## ADDENDUM No. 3

### RFP No. 26-11

#### N. University and Thayer Improvements

CITY OF ANN ARBOR - ENGINEERING  
N. UNIVERSITY & THAYER IMPROVEMENTS  
PROPOSED STORM - NORTH UNIVERSITY  
SCALE: 1"=20'  
DRAWING NO. 2023-023-42  
SHEET NO. 42 OF 80

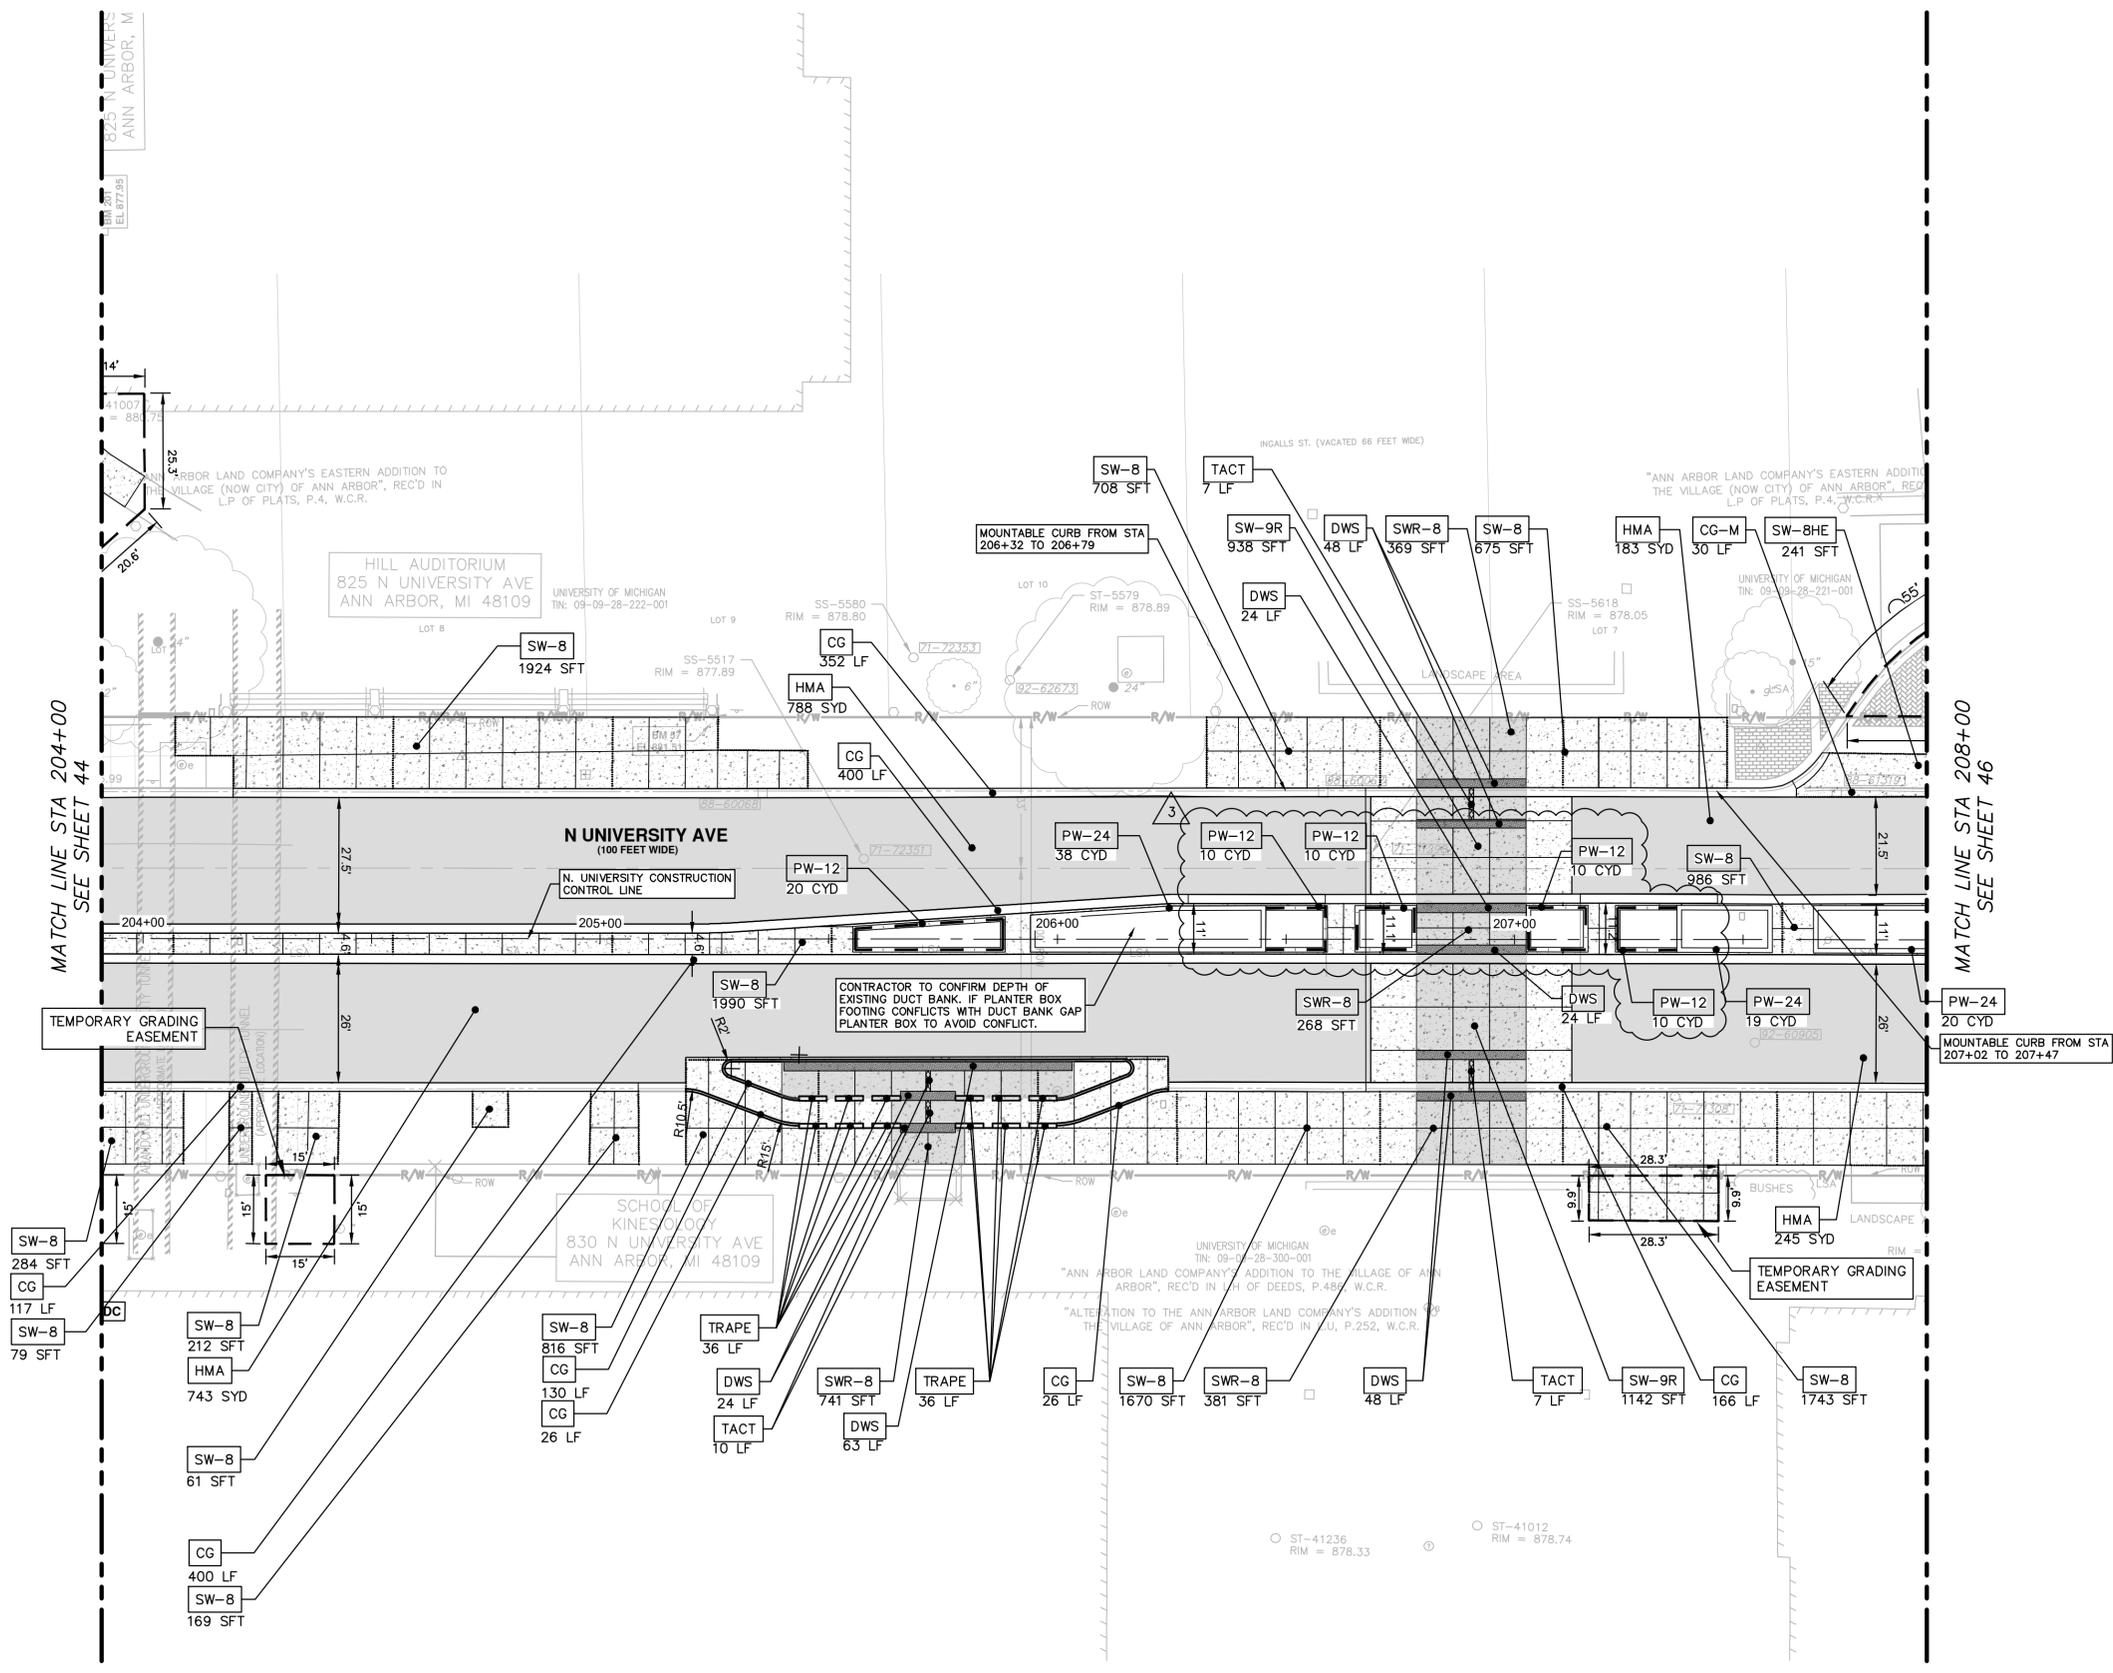
| Plan Sheet 42     | Revision of layout of proposed planter boxes.   |

SHEET No. 45 OF 80

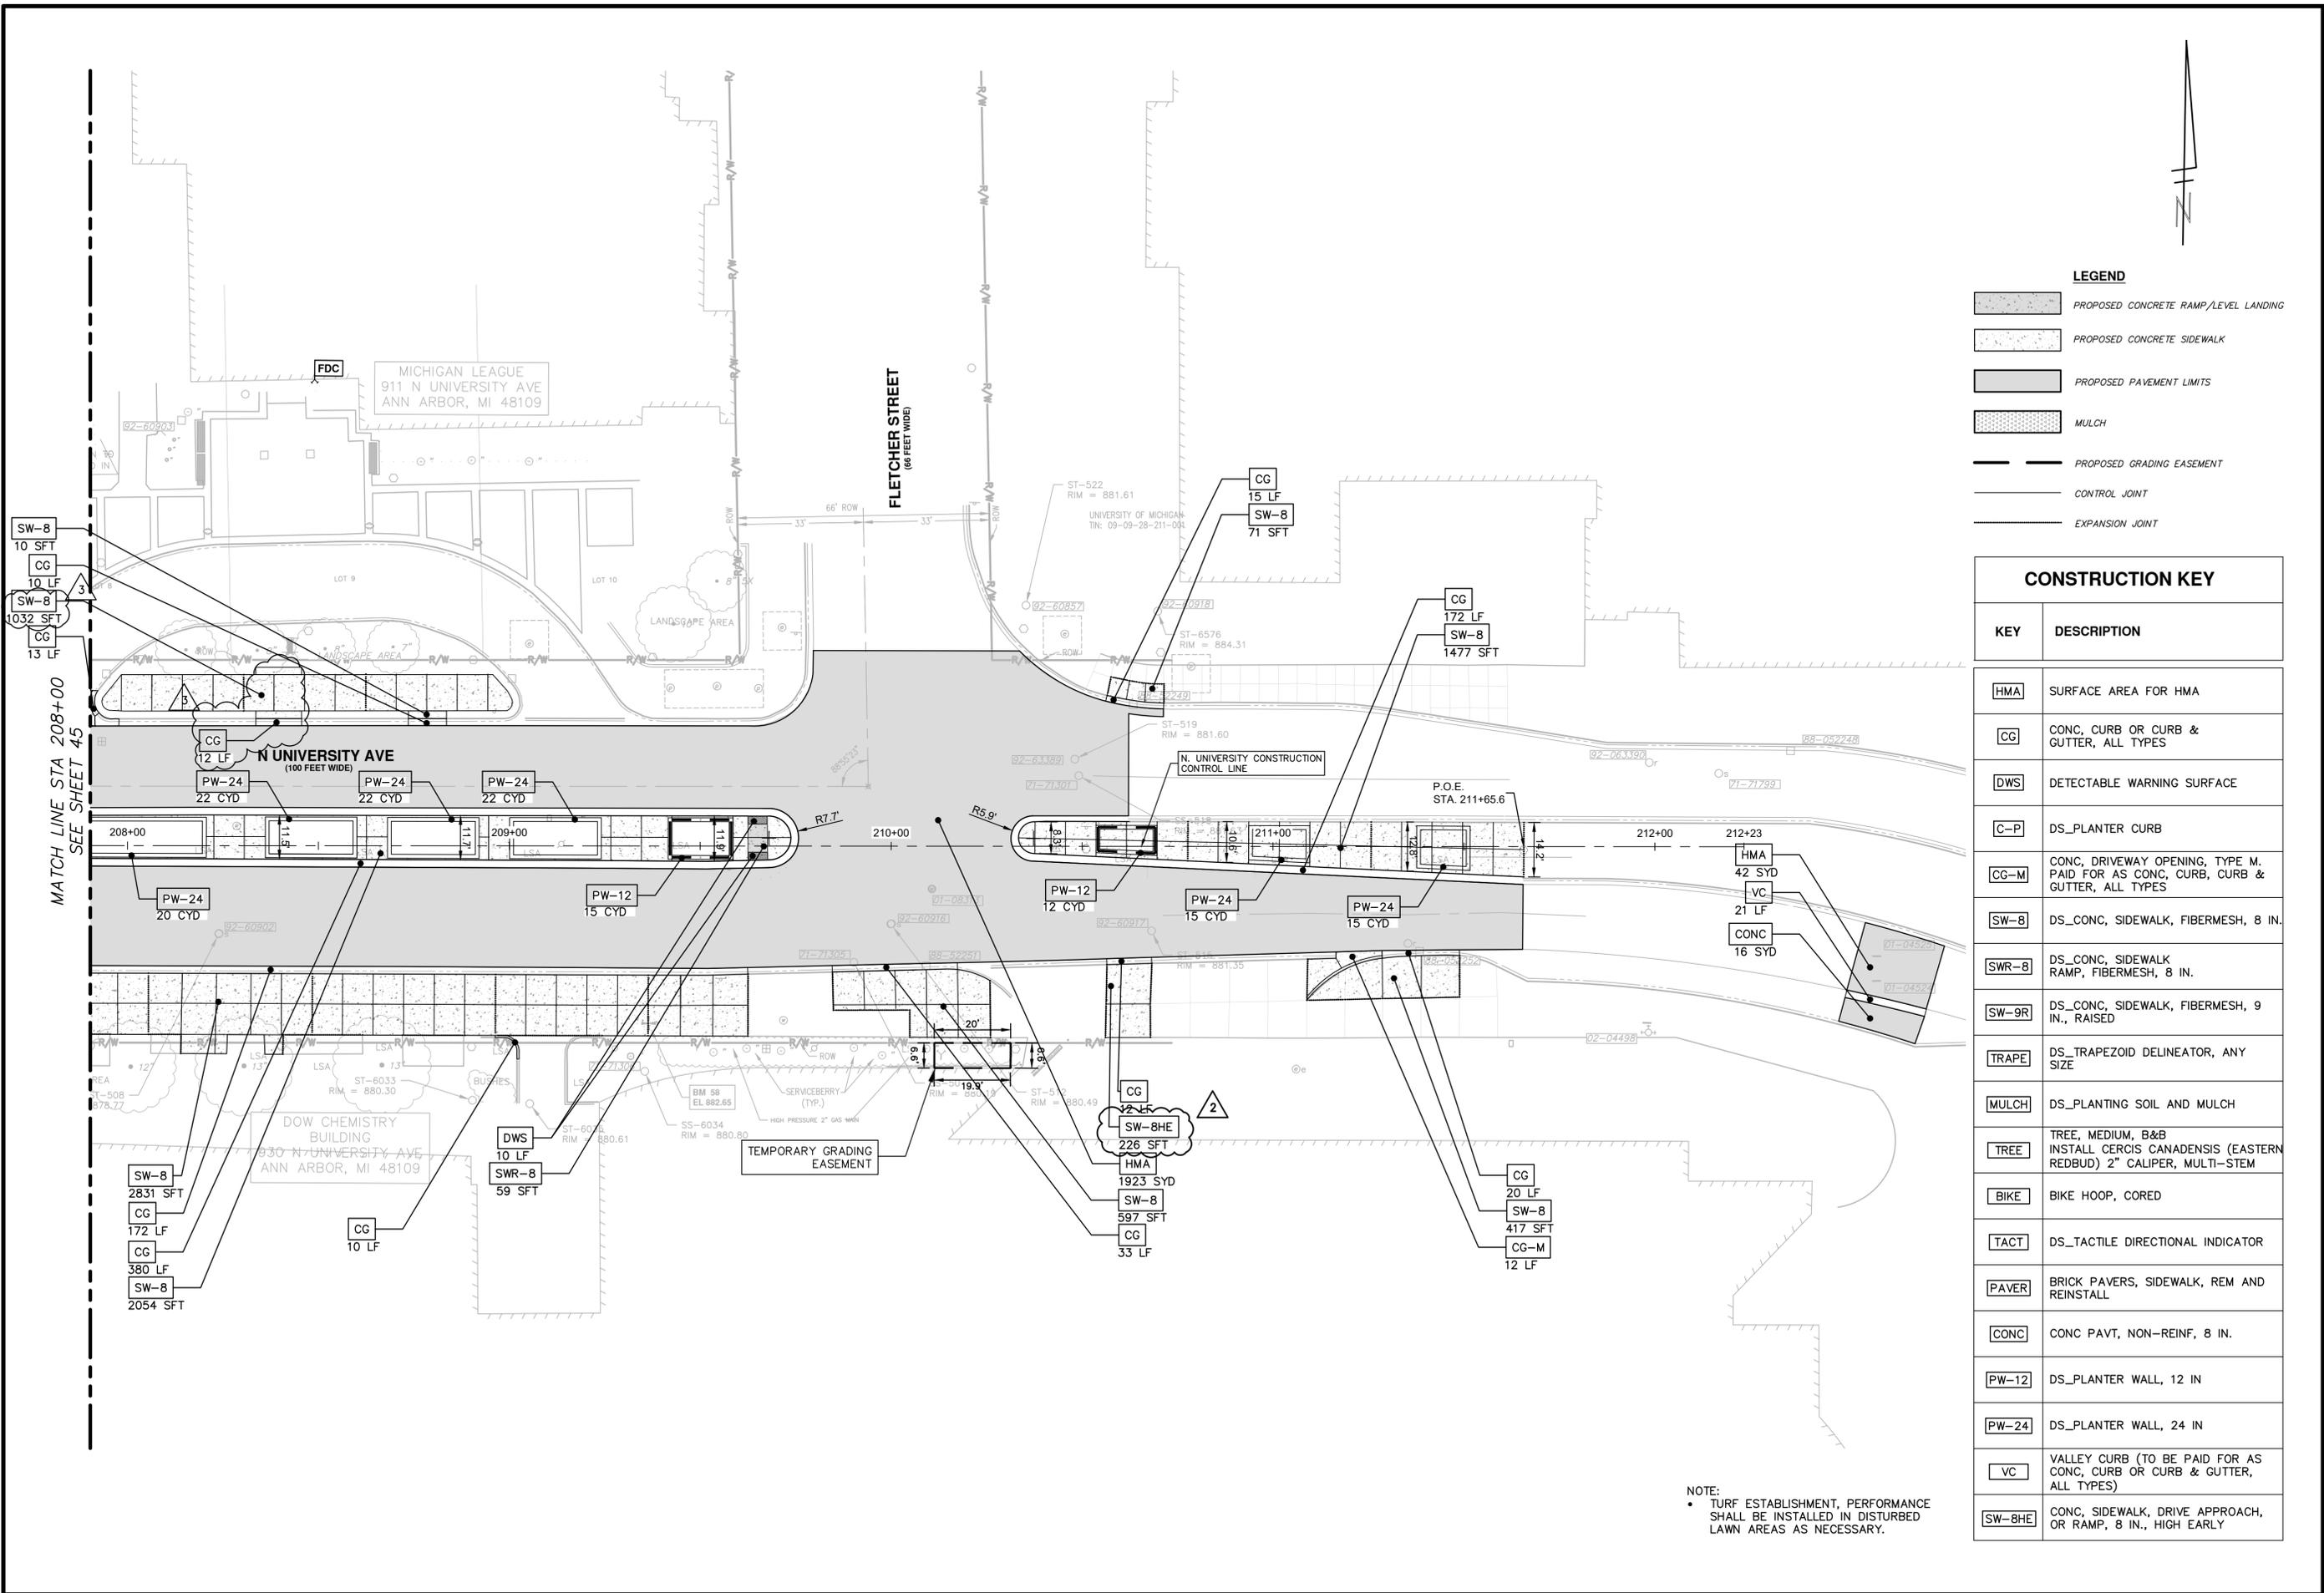
| Plan Sheet 45     | Revision of layout of proposed planter boxes. Quantities have been updated as a result. |
